**Boggabri Coal Mine - Project Approval Modification  
Environmental Assessment (MOD 5)**

**Response to Submissions Report**

2 May 2016

Client: Idemitsu Australia Resources  
Title: Boggabri Coal Mine - Project Approval Modification Environmental Assessment (MOD 5)  
Subtitle: Response to Submissions Report  
Document No: 2200545A-ENV-REP-005 RevI  
Date: 2 May 2016

**Drawdown Impact Assessment of Proposed Borefield Operations, Boggabri Coal Mine**  
**Figure 1**  
 Updated steady state initial heads

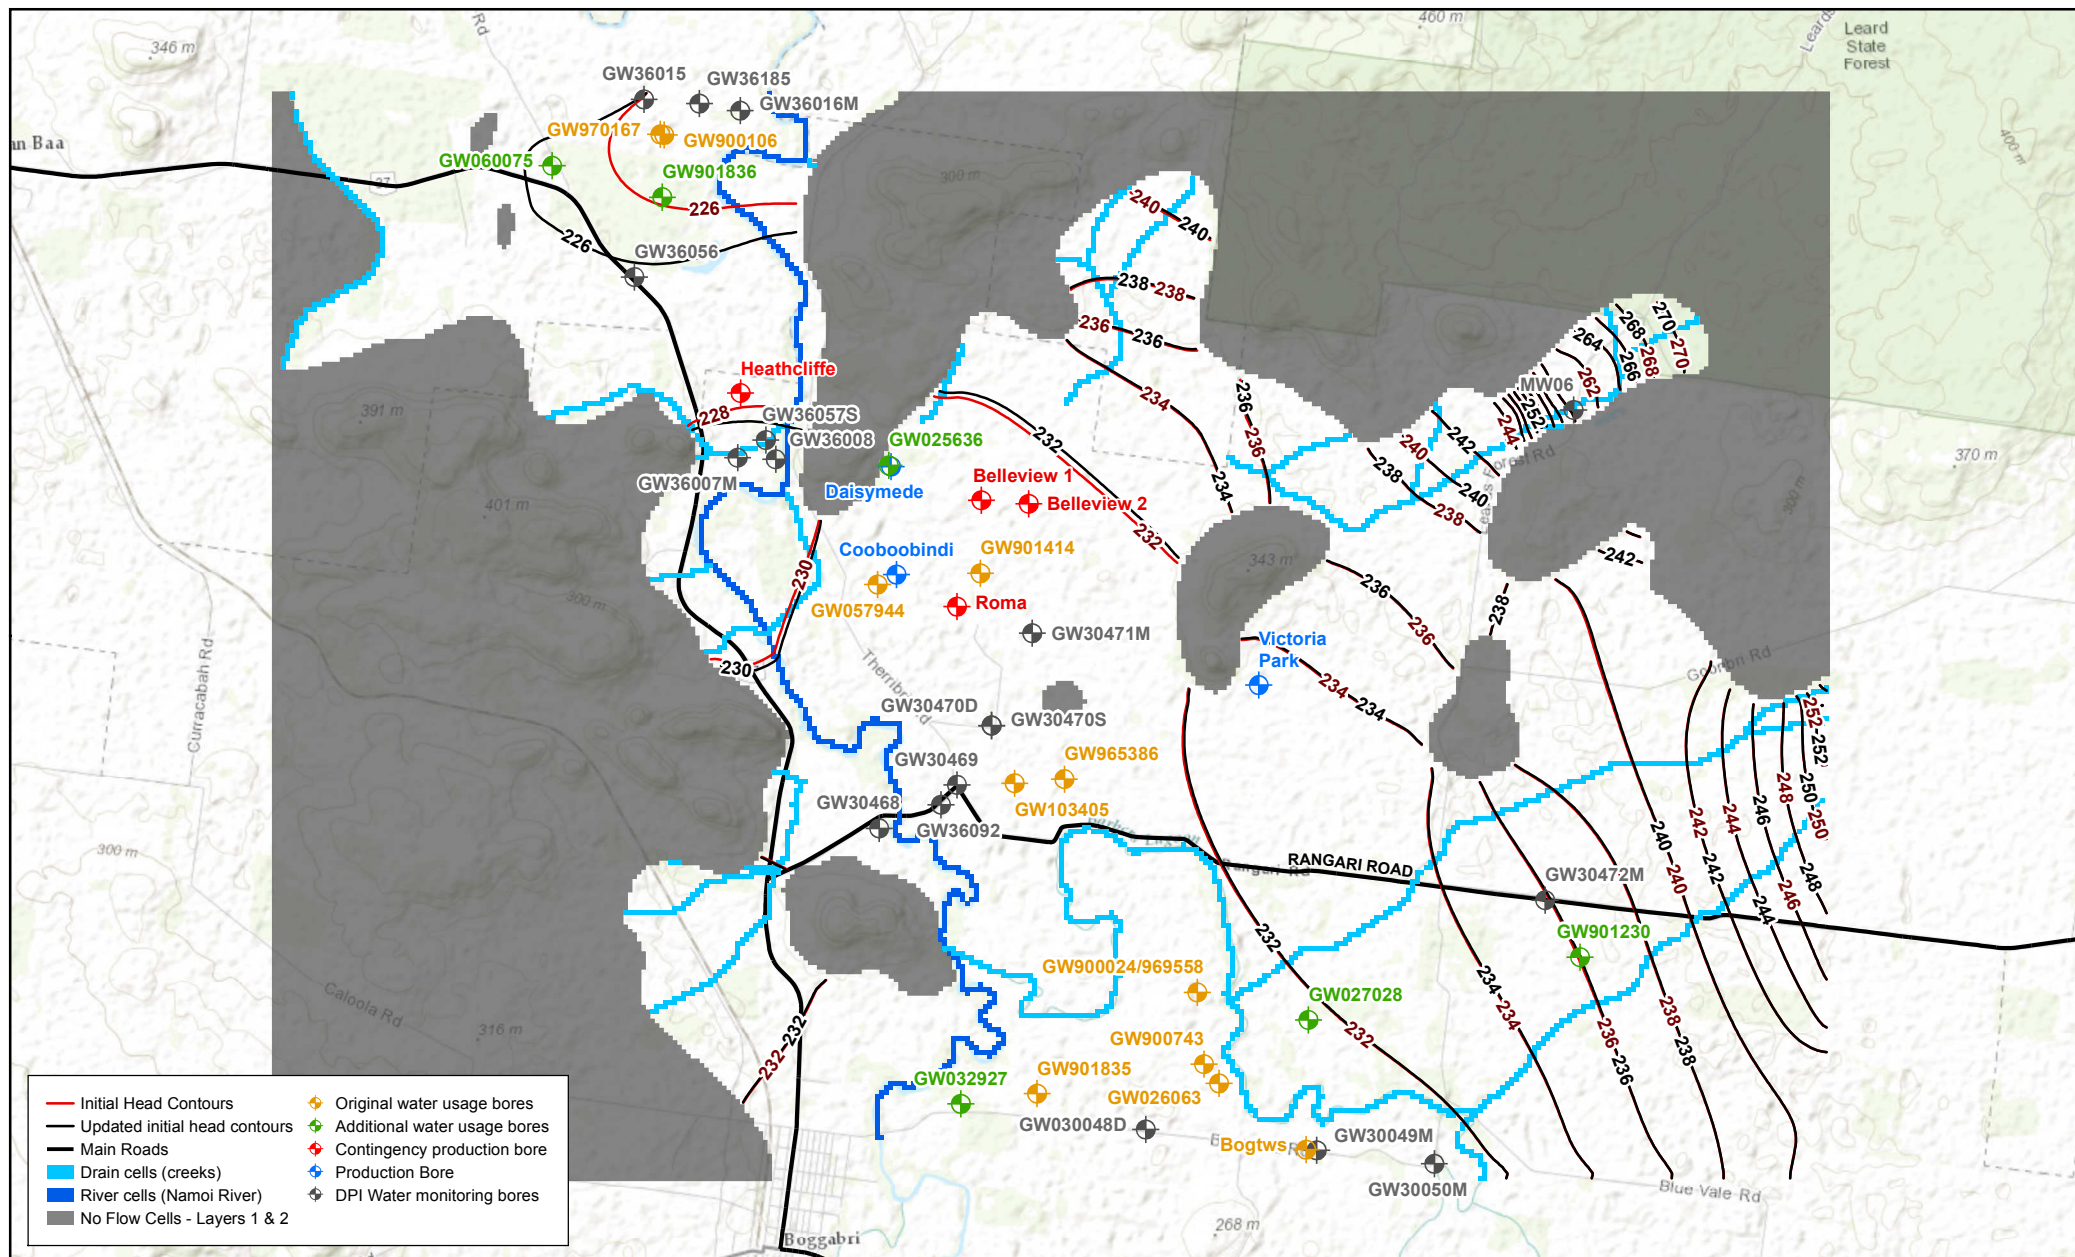
<p><b>Clarification of the groundwater usage data used in the model is required.</b> It appears not all available groundwater usage data was included, this could impact on the accuracy of the model, further explanation is required.</p>	<p>Clarification of the groundwater usage data used in the model is noted in Appendix D of this report.</p> <p>WSP I Parsons Brinckerhoff re-evaluated groundwater usage data from DPI Water records and concluded that six bores (five irrigation bores and old Boggabri town water supply bore GW032927) were omitted from the model. The steady state groundwater model was updated with the additional bore water usage data and rerun.</p> <p>This updated modelling assessment indicated that the additional water usage from third party bores has minimal influence in the model within the area of operations of the three production bores: Coobooobindi, Daisymede and Victoria Park. There is some disparity in modelled outcomes north of the Heathcliffe contingency bore where there are historic records of notable water usage from irrigation bores GW060075 and GW901836. A recalibration of the model hydraulic properties, and subsequent rerun of the simulated drawdown scenarios is not considered necessary. Recalibration in this northwestern model area is expected to provide slightly lower hydraulic conductivity values as the current simulated groundwater level at monitoring bore GW36056 is underestimated. A zoned lower hydraulic conductivity value in the northwestern area of the model would be expected to reduce the extent of drawdown impacts from Boggabri Coal pumping bores in this area.</p>

WSP | Parsons Brinckerhoff re-evaluated groundwater usage data from DPI Water records and concluded that six bores (five irrigation bores and old Boggabri town water supply bore GW032927) were omitted from the model. Table 1 presents the additional bores and water usage data extracted from the DPI Water records. Figure 1 shows the location of water usage bores.

The steady state groundwater model was updated with the additional bore water usage data and rerun. The simulated groundwater heads were compared to the original model steady state run. The differences between groundwater heads was minimal in the borefield region. The most noticeable disparity in groundwater heads occurred in the northwestern area of the model domain (north of the Heathcliffe contingency bore) with a maximum head difference of 0.9 metres. This is because of water usage from the added irrigation bores: - GW901836 and GW060075 (Refer to Figure 1 showing a comparison of steady state groundwater head contours).
